Product Change Notification

Product Group: OPT/Tuesday July 28, 2026/PCN-OPT-1502-2026-REV-0

Qualification of new chipset and BOM for VOR1142M4, LH1546AEF solid state relay family

Fig. 10 - Off-State Leakage Current vs. Load Voltage

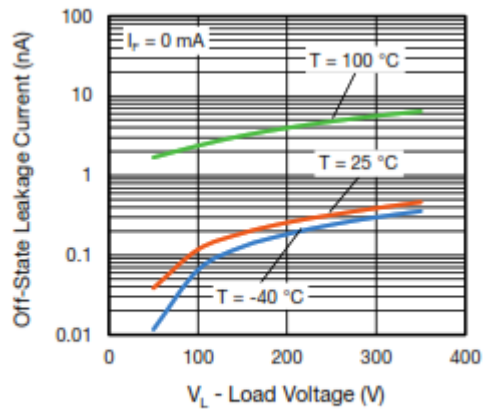
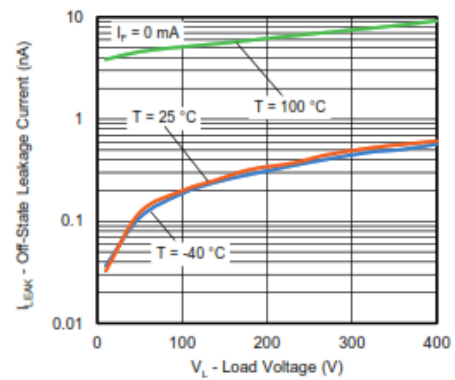
Expected Influence on Quality/Reliability/Performance: There is no change in form, fit and function of the affected parts. The performance as well as the reliability remains unchanged. Min and Max values for the affected parts remain unchanged. However, the deviations in the typical performance are highlighted in the attached comparison report.

VOR1142, LH1546AEF series
